Specialist Response – Fast-track Approvals Act 2024

Substantive Application

Project name	Kings Quarry Expansion – Stage 2
Applicant	Kings Quarry Limited
Site address	Pebble Brook Road, Wainui
Fast-track reference number	FTAA-2502-1018
Types of approvals sought	Application for resource consents (as a non-complying activity overall under the RMA) relating to proposed vegetation removal, earthworks and land disturbance, stream reclamation, diversion / dewatering of groundwater and discharges to air.
Council reference numbers	BUN60450001 (LUC60450002 / WAT60450003 / WAT60450004 / DIS60450005 / LUS60450006)
Description of the proposal	To expand existing quarrying activities to enable the extraction and processing of up to 500,000 tonnes (approximately) of aggregate per annum for up to 45-years. Includes the removal of approximately 28.97ha of existing indigenous SEA vegetation and 2,439 lineal metres of existing stream habitat. Also includes proposed remediation planting and offsets.

Date: 3 July 2025

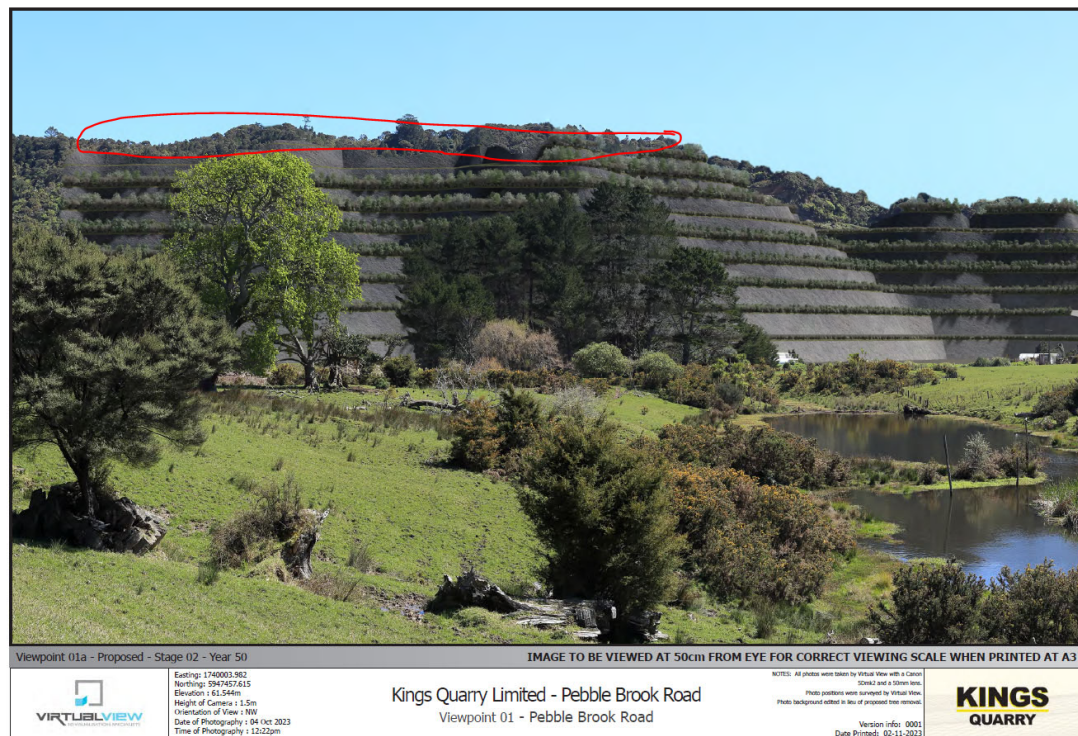
When confirming these assessment findings, it would be helpful for the applicant to confirm that the visual simulation images for Viewpoint RVP-1 have correctly illustrated the extent of existing mature vegetation that is shown to remain at the ridgeline to the west of the proposed quarry face (within the red circled area in the image below). I suggest that it would be helpful to view the 3D-model base for these images to confirm understandings.
